CHICAGO TRANSIT AUTHORITY  
Advertisement for Bids

NOTICE OF TIME EXTENSION AND ADDENDUM #1

Req No: C11RI101126074, Spec. No. CTA 0039-10  
Purple Line Viaduct Replacements: Greenleaf Street,  
Dempster Street and Grove Street and Retaining Wall  
Rehabilitation.

**Contract No. C11RI101126074:****Purple Line Viaduct Replacements: Greenleaf Street, Dempster Street, Grove Street and Retaining Wall Rehabilitation Response to Bidders' Questions**

SCALE: 1/4" = 1'-0"

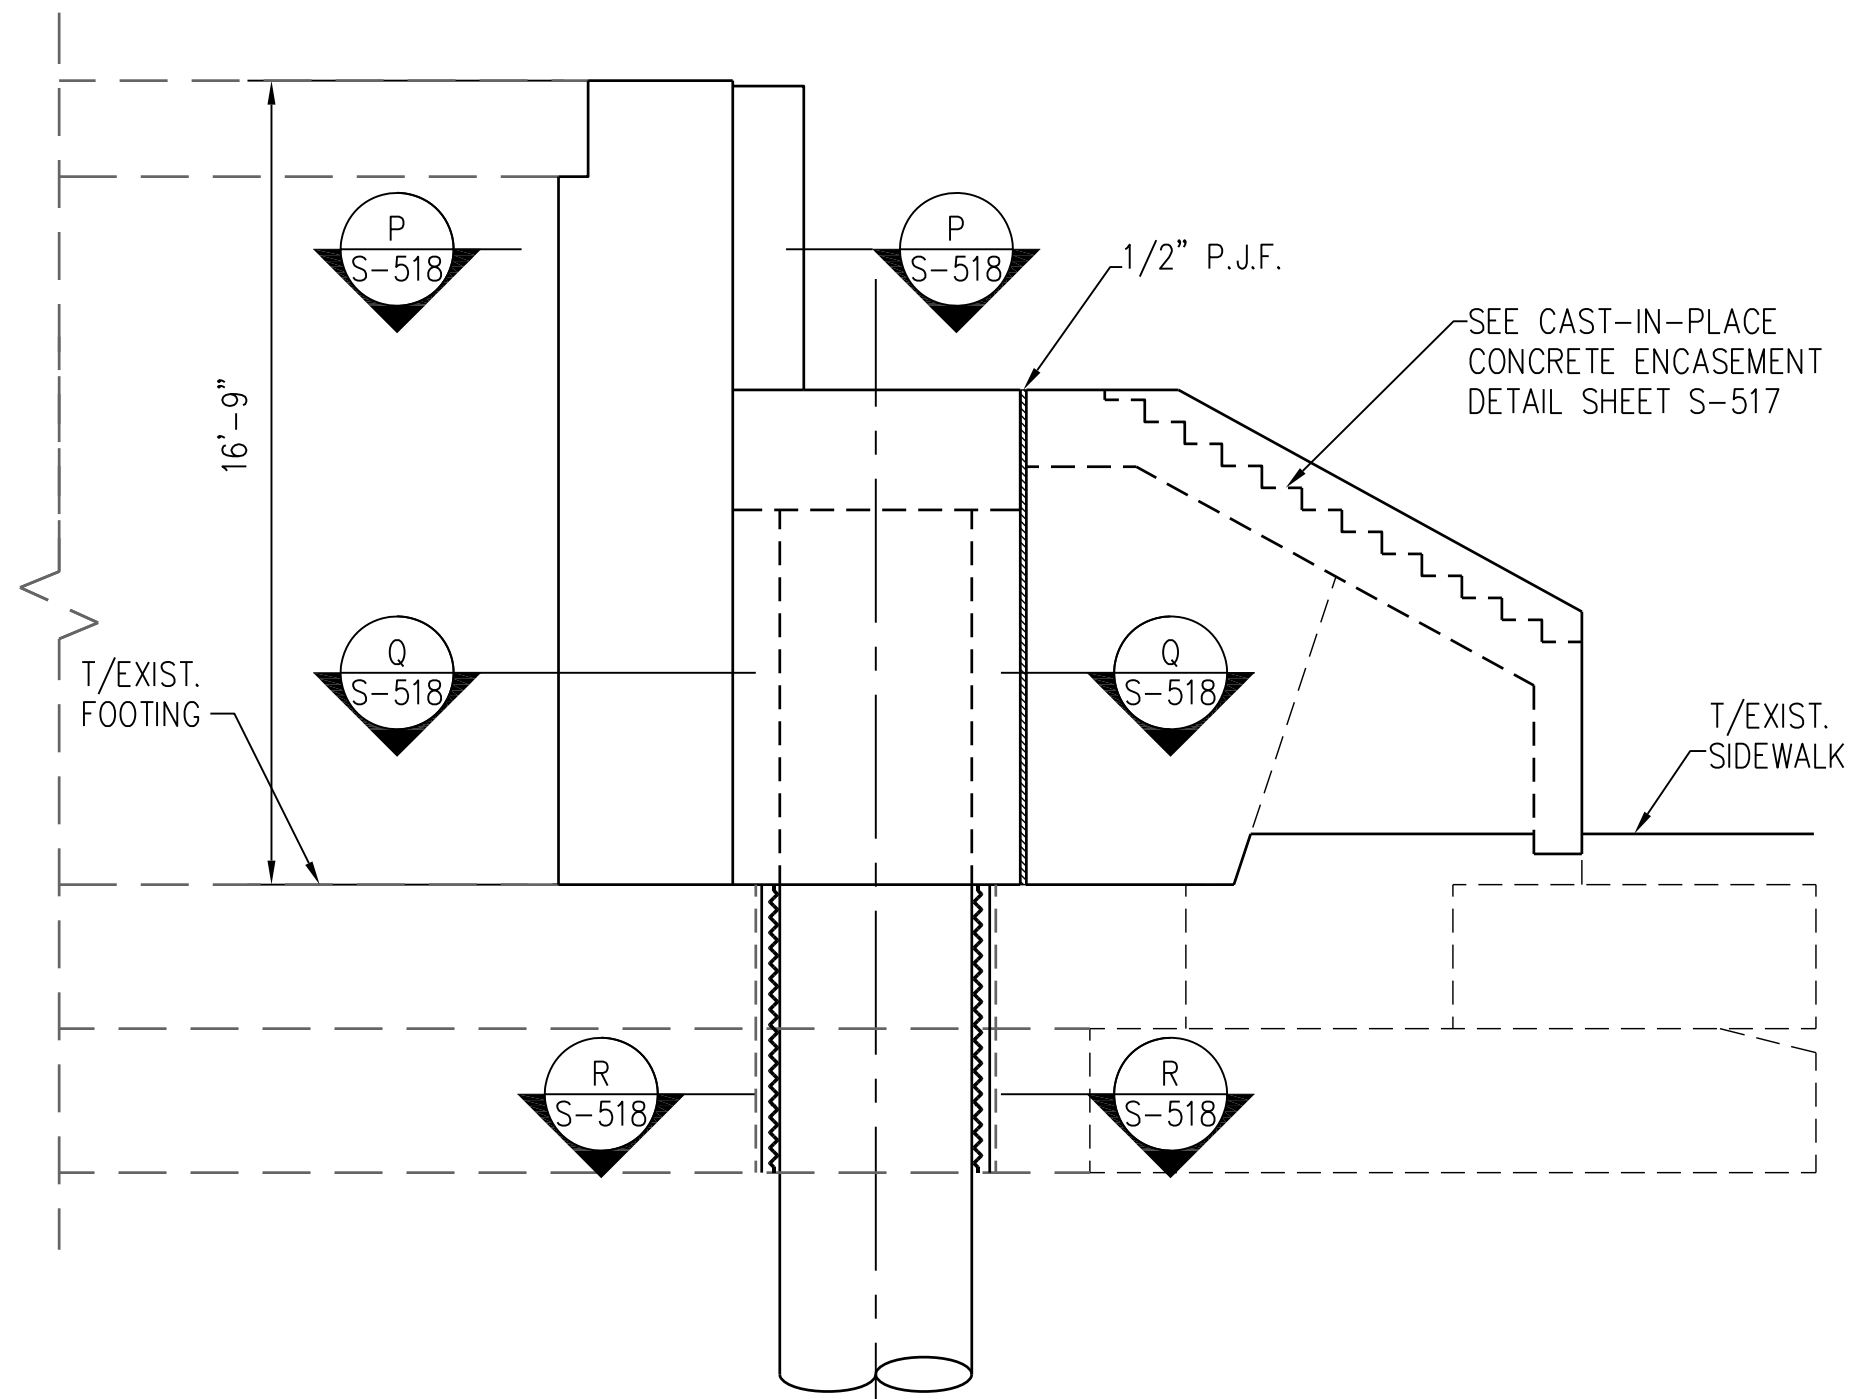
6		SGRE-516, SXGRE-003	Missing Drawings	Contract plan set is missing Sheet SGRE-516 "Proposed North Abutment". Sheet SDEM-516 has incorrectly been included in its place. Please provide this drawing sheet. Contract plan set is missing Sheet SXGRE-003 "Staging Location". Sheet SXGRO-003 has incorrectly been included in its place. Please provide this drawing sheet.	Addendum No. 1.
7	3200	WAL S-501 G-003	Galvanized Rebar	Rebars have (E) designation on S-501 while Note 3F on Sheet G-003 calls out galvanized rebar. The Spec. 3200 also calls out hot dip galvanized. Please clarify if rebar is to be epoxy coated or galvanized?	Rebar "(E)" designation has been removed. Per section 3200 all reinforcement shall be galvanized. See addendum No. 1.
8		WAL S-501		On drawing no. WAL S-501, Typical Wall Repair Details, It indicates that all the reinforcing steel used in the retaining wall repairs are Epoxy coated. Is this correct or should it be galvanized? And should the mesh be galvanized?	Per section 3200 all reinforcement shall be galvanized. See Addendum No. 1.

DRAWING NO. WAL S-007

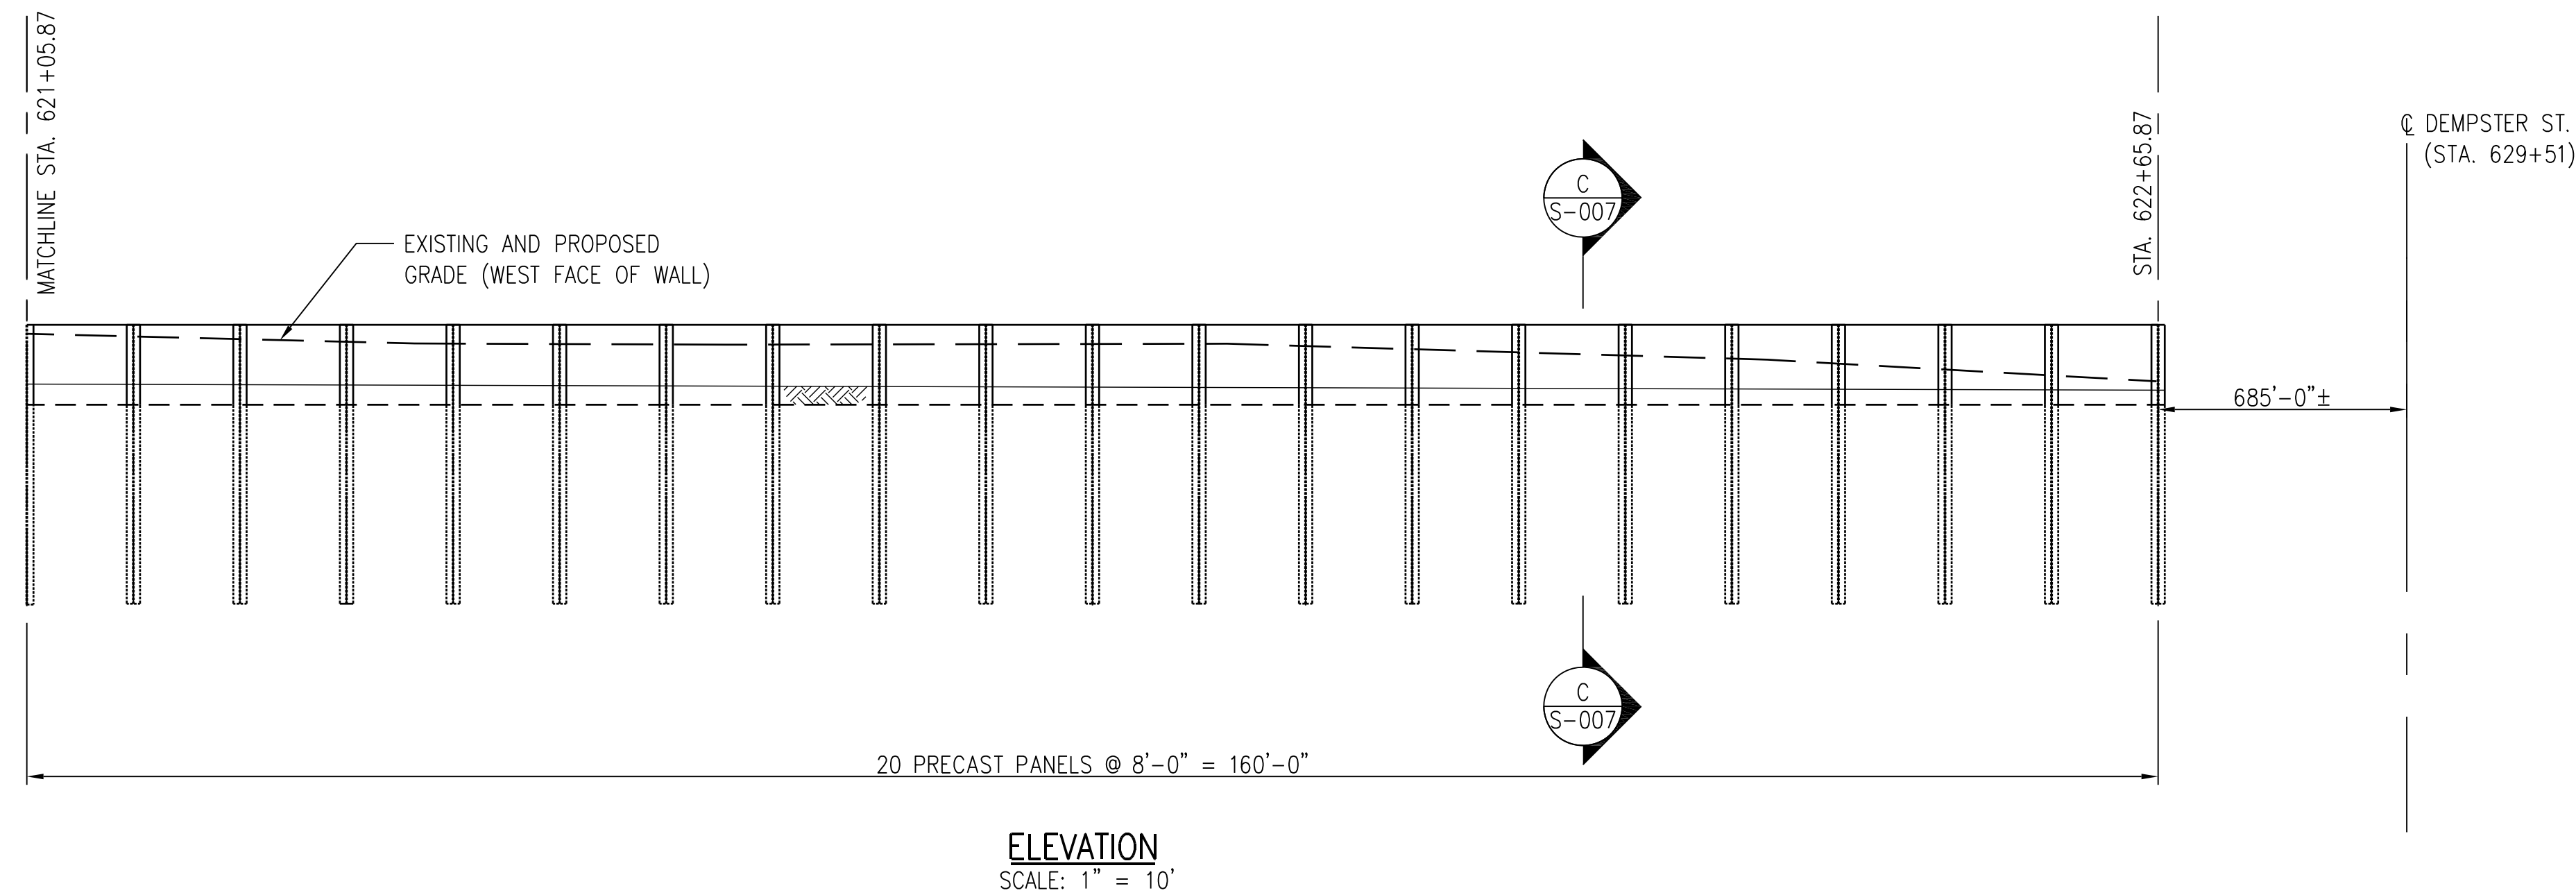
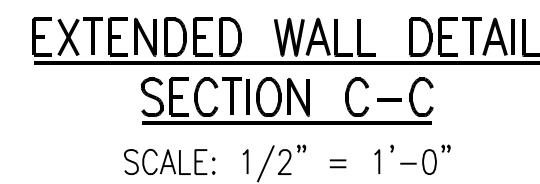
9		WAL S-007, WAL S-008	HP 10x420 Galvanized	Sheet WAL S-008 calls out the HP 10x42 as galvanized while Sheet WAL S-007 does not require the HP 10x42 to be galvanized. Please clarify.	All HP 10x42 shall be galvanized. See Addendum No. 1.
10	7101 3.04B	SGRE-507, SDEM-507, SGRO-507	Floor Deck Plate Painting	The Spec. states that the surface preparation is to be near white SSPC SP-10 clean. Note 3 on each of the drawings states the deck plate to be prime painted. Is the prime paint only on the bottom side?	All ballast deck plate surfaces shall be prime painted unless the surface is to receive the membrane waterproofing. Surfaces that are to receive membrane waterproofing shall be prepared as specified in Specification Section 7101 Part 3.
11	6101	CT-502	Cross Ties	Please clarify the timber cross tie dimensions.	7"x9"x9". See Addendum No. 1
12		TS-500, TS-501, CT-502	Chair Tie Stagger	Cross ties on sheet TS-500 have no stagger, while cross ties on Sheet TS-501 have a stagger, and Sheet CT-502 indicates a 9'-6" tie. Please clarify tie dimensions and stagger requirements	Addendum No. 1.
